THE GLEN AT WIDEFIELD SUBDIVISION FILING NO. 12

A portion of the South One-half (S1/2) of Section 22
Township 15 South (T15S), Range 65 West (R65W) of the 6TH P.M.
County of El Paso, State of Colorado

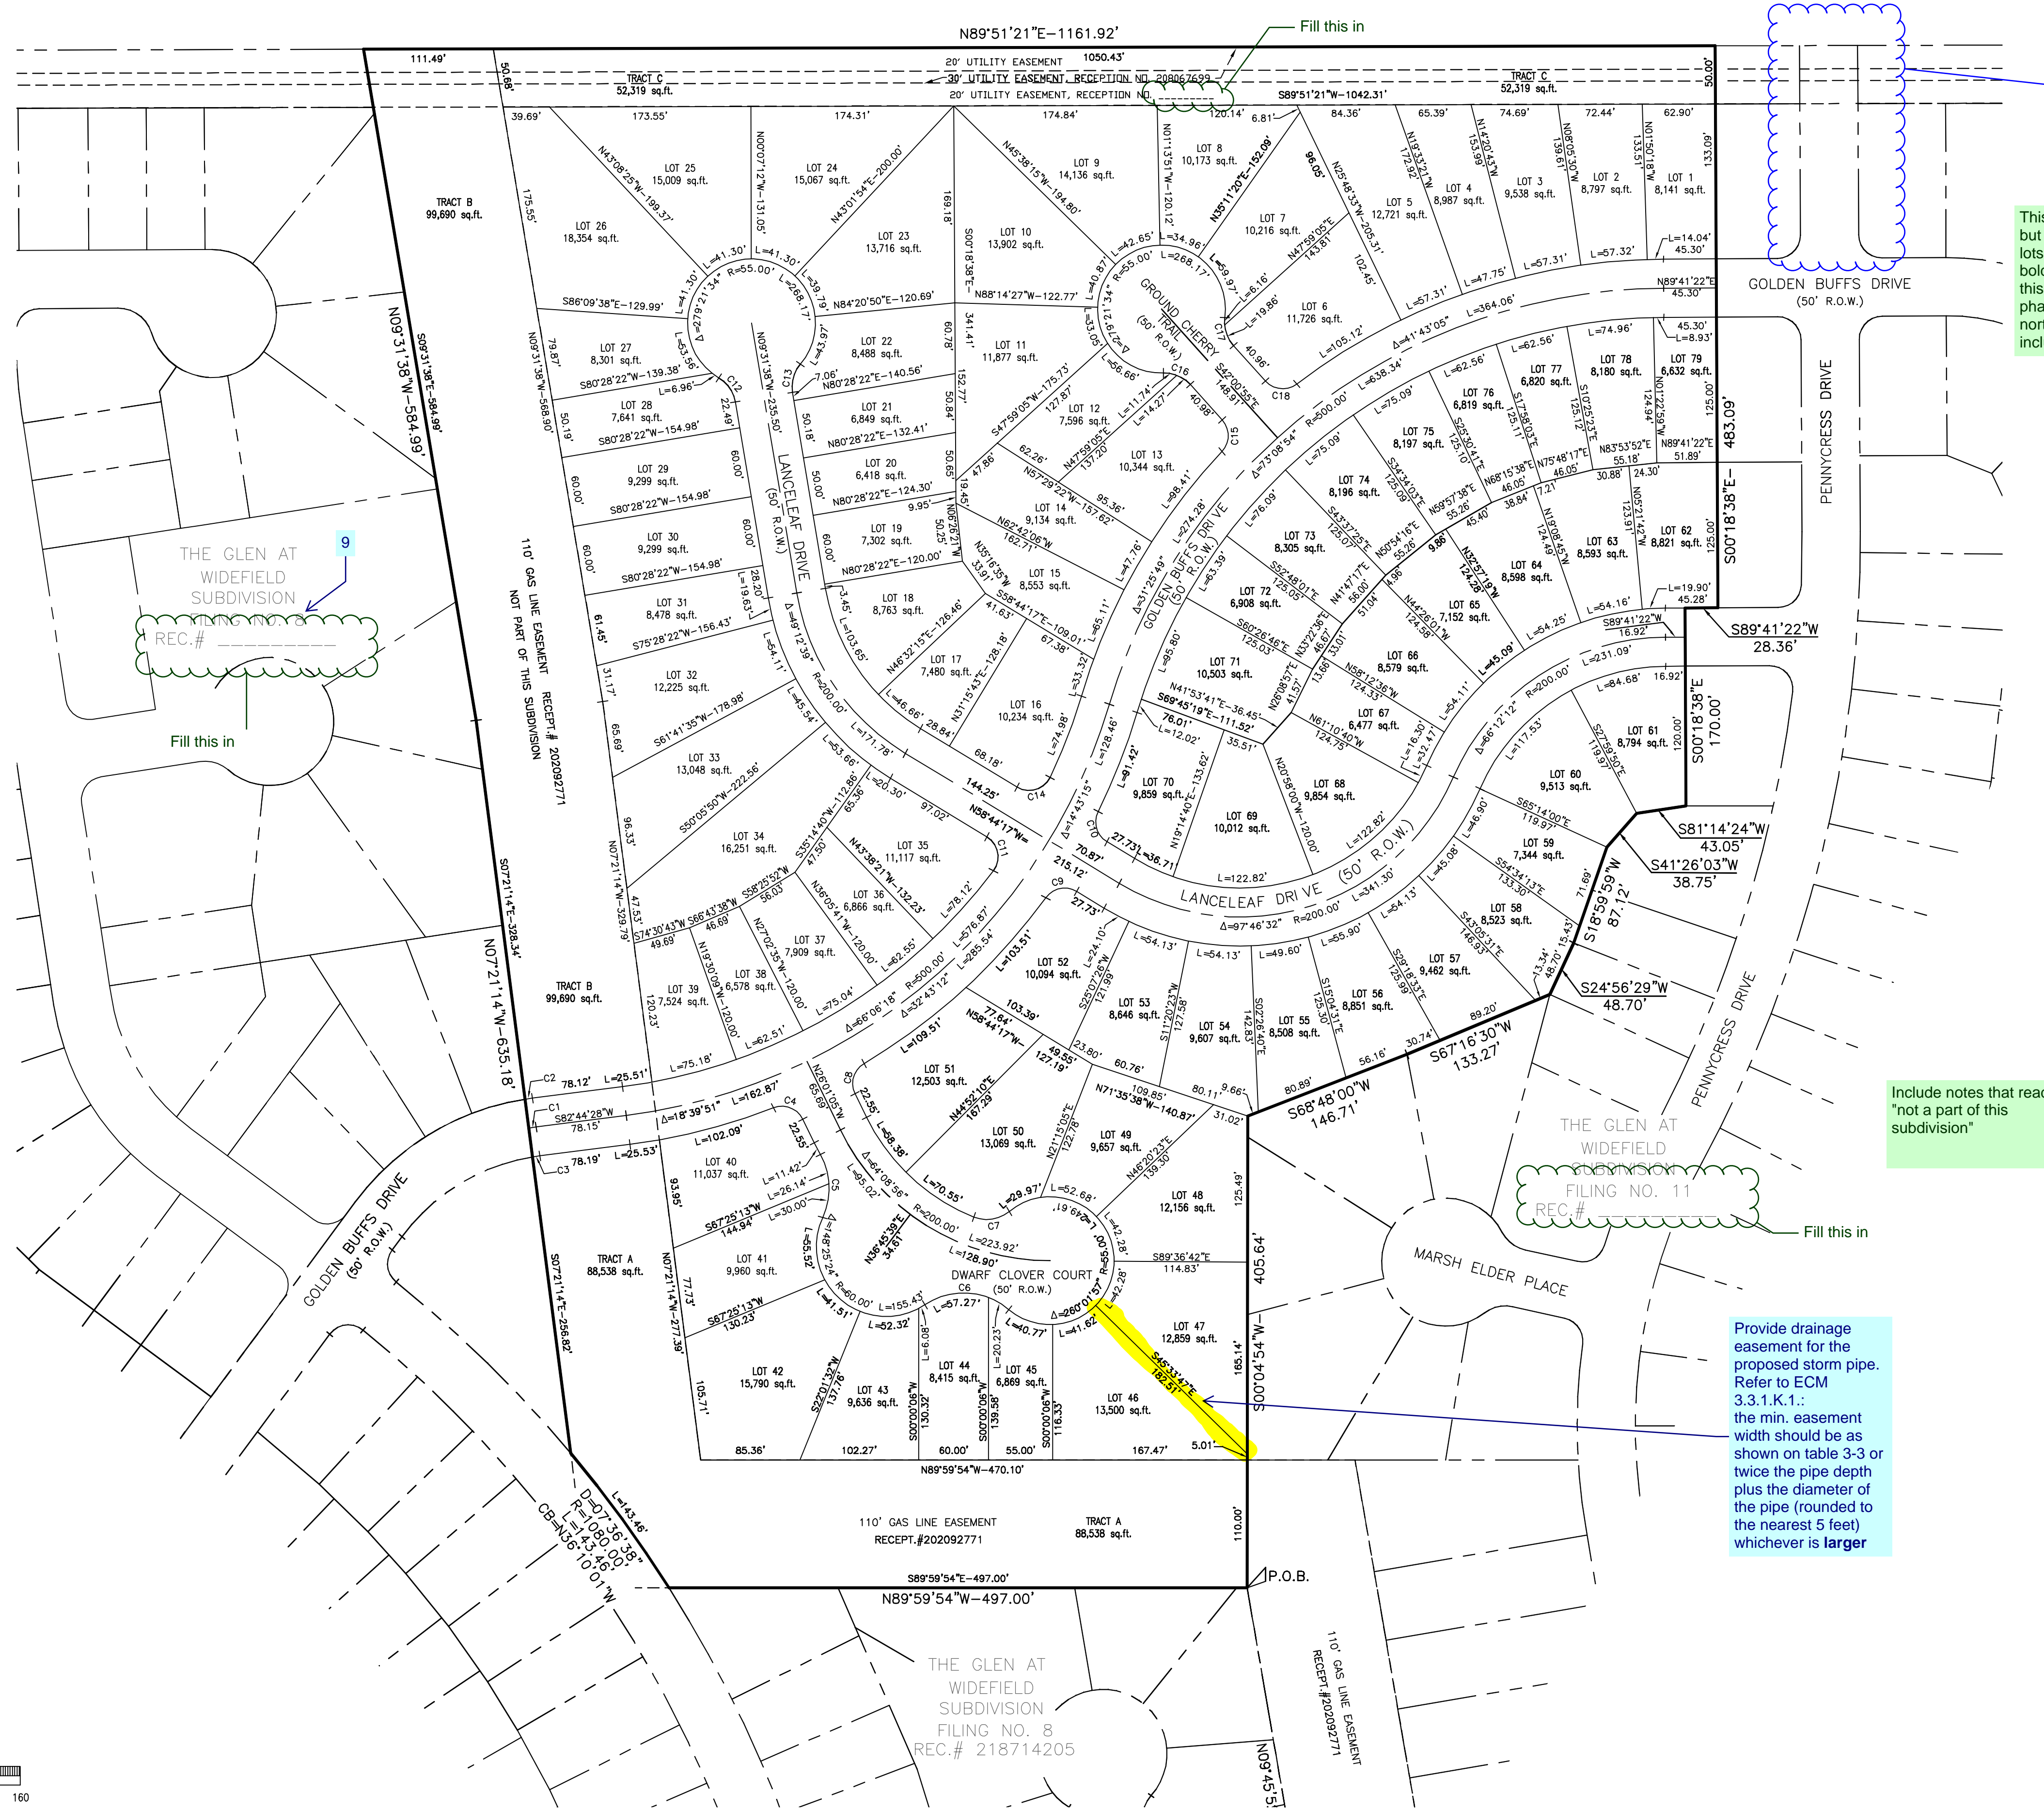
This might just be a display error, but it appears that the text on the lots south of Golden Buffs Drive is bold. Is there any significance to this? It gives the appearance of a phased plan or that the lots on the north side may not be included.

Include notes that read "not a part of this subdivision"

Provide drainage easement for the proposed storm pipe. Refer to ECM 3.3.1.K.1.: the min. easement width should be as shown on table 3-3 or twice the pipe depth plus the diameter of the pipe (rounded to the nearest 5 feet) whichever is larger
